UNITED STATES PATENT AND TRADEMARK OFFICE

APPLICATION NO.	FILING DATE	FIRST NAMED INVENTOR	ATTORNEY DOCKET NO.	CONFIRMATION NO.
10/507,453	09/13/2004	Gerd Reime	REP-0027	1401

Office Action Summary

DETAILED ACTION

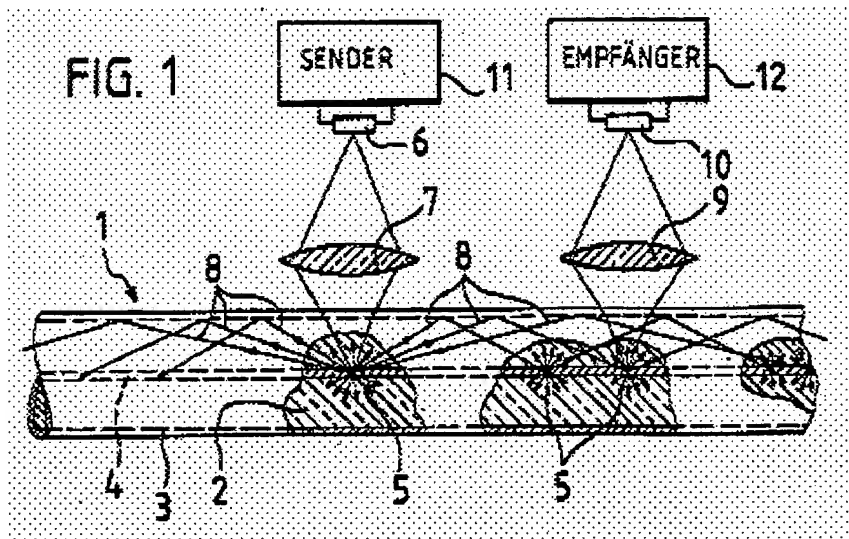
With respect to claims 26, 40 and 41, Walter et al. (figure 1) disclose a device for optoelectronically detecting movement and/or position of an object comprising at least one transmitting element (11) for emitting radiation in the optical wavelength range and at least one receiving element (12) for receiving at least a part of the radiation emitted by the transmitting element and reflected back by the object and also comprising an optical guide (1) arranged in the beam path between the transmitting element and the receiving element (see figure 1), wherein the optical guide (1) comprises at least one light coupling element (2) for at least one of coupling-in the radiation previously radiated through the optical guide (1) and diffusely scattered at the object transversely to the longitudinal extent of the optical guide, and coupling-out radiation radiated to the optical guide by the transmitting element transversely to the longitudinal extent of the optical guide; wherein signals derived by the at least one receiving element are used as input for a writing recognition system and the at least one transmitting element (11) remains illuminated after a key associated therewith is actuated (see figure 1 and the abstract).

With respect to claims 28 and 29, Walter et al. (figure 1) disclose the device, wherein the radiation radiated through the optical guide (1) by the transmitting element (11) is radiated transversely through the optical guide from the side opposite the object and wherein radiation emitted along the optical guide (1) by the transmitting element (11) is at least partially coupled-out of the optical guide by the at least one light coupling element (2) before it is scattered by the object.

With respect to claim 30, Walter et al. (figure 1) disclose the device, wherein the at least one light coupling element (2) is a forming at the side of the optical guide facing away from the object transversely approaching the optical guide (1).

With respect to claims 31 and 33, Walter et al. (figure 1) disclose the device, wherein the optical guide (1) comprises a plurality of light coupling elements (2) which are spatially associated with a respective transmitting element (11) and wherein the transmitting elements are arranged in the form of a keyboard and in that a curved or circular-segment-shaped light coupling element is associated with each key (see figure 1).

With respect to claims 38 and 39, Walter et al. (figure 1) disclose the device, wherein a plurality of light coupling elements (2) is arranged in the form of a matrix or a circle (see figure 1).
